**WRITTEN OPINION OF THE
INTERNATIONAL SEARCHING AUTHORITY**

PCT/US04/09495

GREEN TOKAI CO., LTD.

FIG. 3

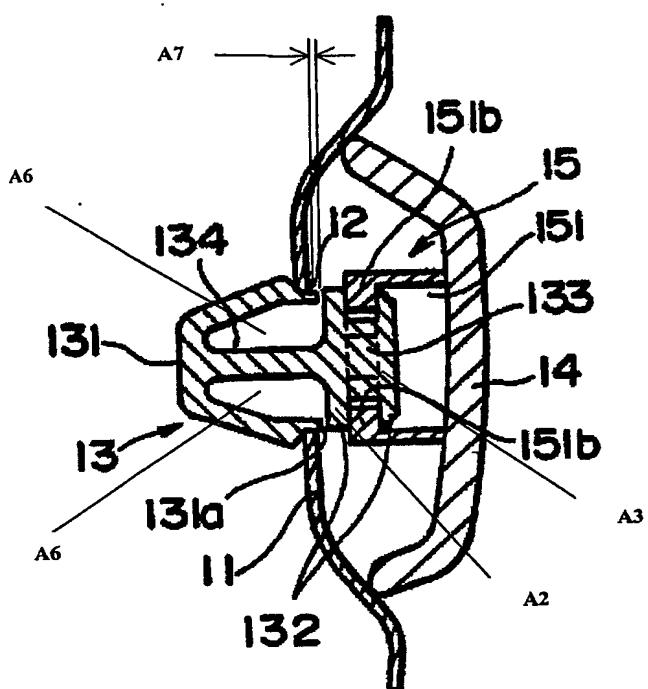
Regarding claim 1, Maki discloses, in Fig. 3, a clip comprising a base 132, a male member 131, raised surface portions 131a, a first attachment channel A8, a second attachment channel A9, and a common wall 133. The base 132 has a top portion A2 and a bottom portion A3. The male member 131 extends outwardly from the top portion A2. The raised surface portions 131a are formed on opposing sides A6 of the male member 131 with a gap A7 defined between the raised surface portions 131a and the top portion A2. The first attachment channel A8 and the second attachment channel A9 are formed in the base 132 and are in generally parallel relation to each other, and separated by the common wall 133 extending between the top portion A2 and the bottom portion A3. The first attachment channel A8 and the second attachment channel A9 have elongated openings A11 facing in opposing directions A13.

Regarding claim 2, the male member 131 comprises a longitudinal axis A14. The base 132 comprises a central axis A15. The male member 131 is eccentrically positioned relative to the central axis A15 on the base 132.

Regarding claim 3, the base 132 comprises a longitudinal extending axis A16 perpendicularly related to a central axis A15 of the base 132 and bisecting the base 132. The common wall 133 extends parallel to the longitudinal extending axis A16 and the common wall 133 is laterally spaced from the longitudinal extending axis A16.

Regarding claim 8, the raised surface portions 131a of the male member 131 present smoothed, radiused surfaces A17.

FIG. I

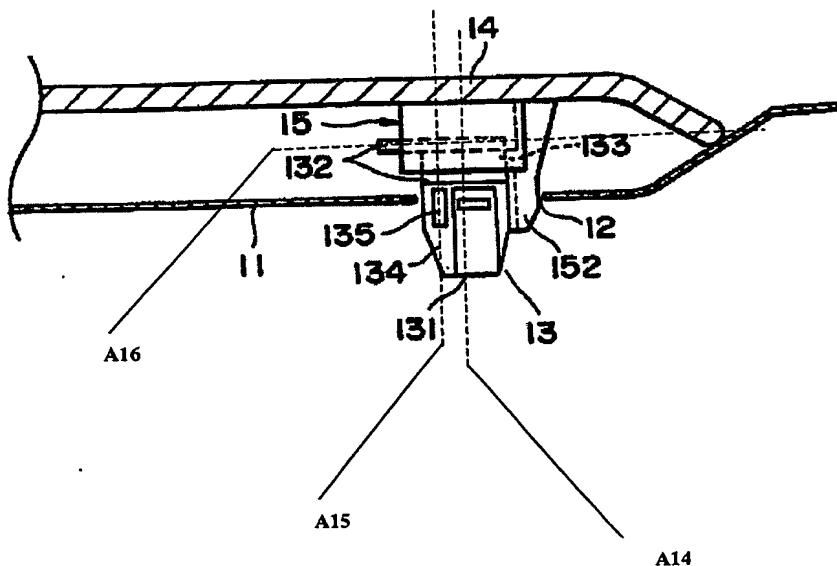
Regarding claim 9, Maki discloses, in Figs. 1, 3 and 5, a composition comprising a clip 13, and a clip house 15 attached to an automotive trim part 14 and comprising an inclined mounting portion 151c. The clip comprising a base 132, a male member 131, raised surface portions 131a, a first attachment channel A8, a second attachment channel A9, and a common wall 133. The base 132 has a top portion A2 and a bottom portion A3. The male member 131 extends outwardly from the top portion A2. The raised surface portions 131a are formed on opposing sides A6 of the male member 131 with a gap A7 defined between the raised surface portions 131a and the top portion A2. The first attachment channel A8 and the second attachment channel A9 are formed in the base 132 and are in generally parallel relation to each other, and separated by the common wall 133 extending between the top portion A2 and the bottom portion A3. The first attachment channel A8 and the second attachment channel A9 have elongated openings A11 facing in opposing directions A13. The first attachment channel A8 or the second attachment channel A9 slidably engages the inclined mounting portion 151c of the clip house 15 thereby securing the clip 13 to the clip house 15.

Fig. 3

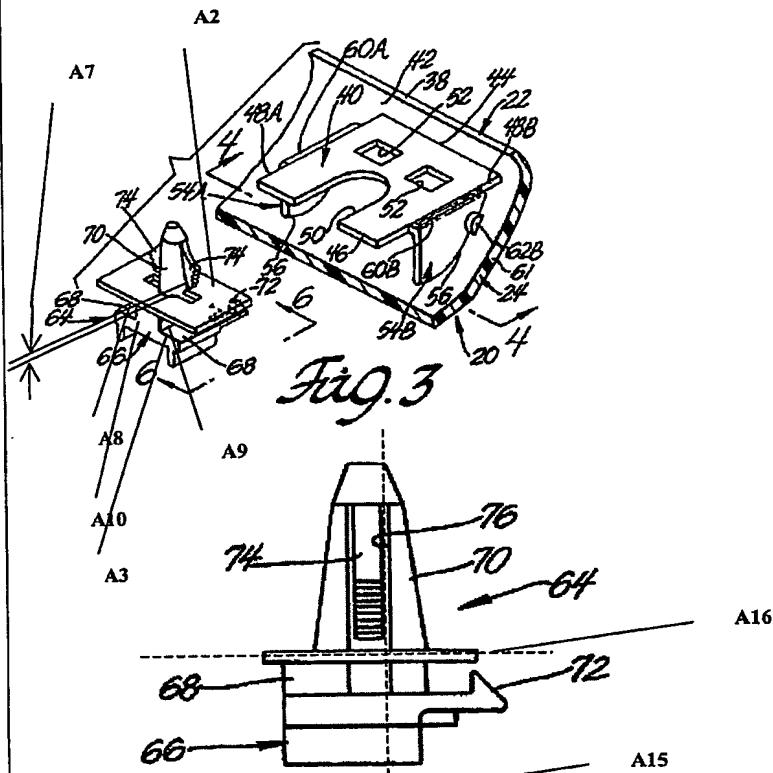
Regarding claim 1, Hingorani et al. disclose, in Figures 3 and 6, a clip comprising a base 66, a male member 70, raised surface portions 74, a first attachment channel A8, a second attachment channel A9, and a common wall A10. The base 66 has a top portion A2 and a bottom portion A3. The male member 70 extends outwardly from the top portion A2. The raised surface portions 74 are formed on opposing sides of the male member 70 with a gap A7 defined between the raised surface portions 74 and the top portion A2. The first

attachment channel **A8** and the second attachment channel **A9** are formed in the base **66** and are in generally parallel relation to each other, and separated by the common wall **A10** extending between the top portion **A2** and the bottom portion **A3**. The first attachment channel **A8** and the second attachment channel **A9** have elongated openings **68** facing in opposing directions.

Regarding claim 3, the base **66** comprises a longitudinal extending axis **A16** perpendicularly related to a central axis **A15** of the base **66** and bisecting the base **66**. The common wall **A10** extends parallel to the longitudinal extending axis **A16** and the common wall **A10** is laterally spaced from the longitudinal extending axis **A16**.

Regarding claim 4, the clip further comprising a flanged area **A18** providing a narrowed portion in the first attachment channel **A8** or the second attachment channel **A9**.

Regarding claim 5, the first attachment channel **A8** and the second attachment channel **A9** each comprises a flanged area **A18** therein, thereby narrowing a portion of each attachment channel.

Fig. 6

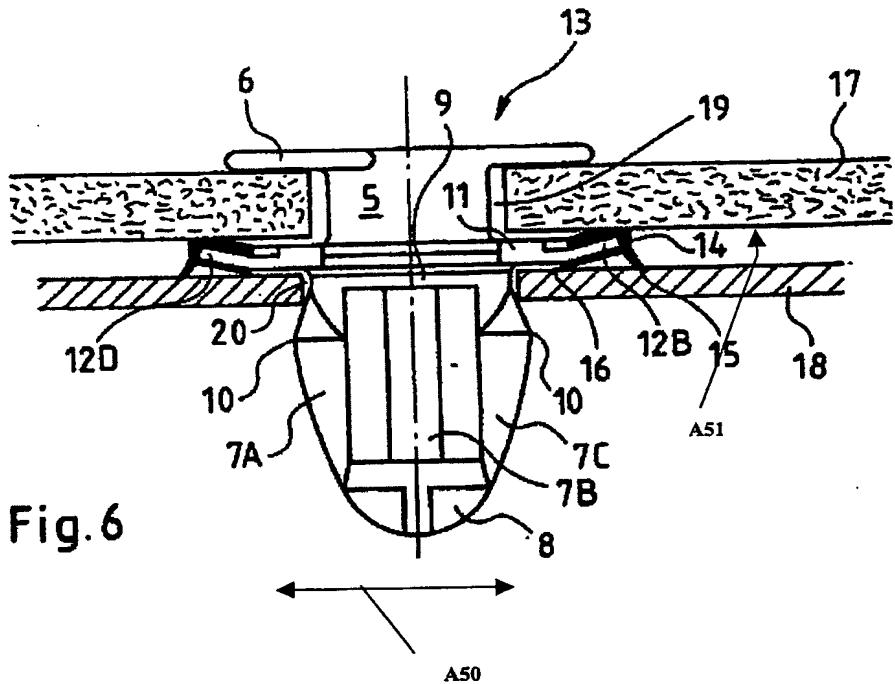
Regarding claim 1, Cordola disclose, in Figures 6, a clip comprising a base, a male member, raised surface portions, a first attachment channel, a second attachment channel, and a common wall. The base has a top portion and a bottom portion. The male member extends outwardly from the top portion. The raised surface portions are formed on opposing sides of the male member with a gap defined between the raised surface portions and the top portion. The first attachment channel and the second attachment channel are formed in the base and are in generally parallel relation to each other, and separated by the common wall extending between the top portion and the bottom portion. The first attachment channel and the second attachment channel have elongated openings facing in opposing directions.

Regarding claim 3, the base comprises a longitudinal extending axis perpendicularly related to a central axis of the base and bisecting the base. The common wall extends parallel to the longitudinal extending axis and the common wall is laterally spaced from the longitudinal extending axis.

Regarding claim 5, the first attachment channel and the second attachment channel each comprises a flange **12B,12D** therein, thereby narrowing a portion of each of the channels.

Regarding claim 6, the flanges face opposing directions **A50**.

Regarding claim 7, the flanges face in a same direction **A51**.
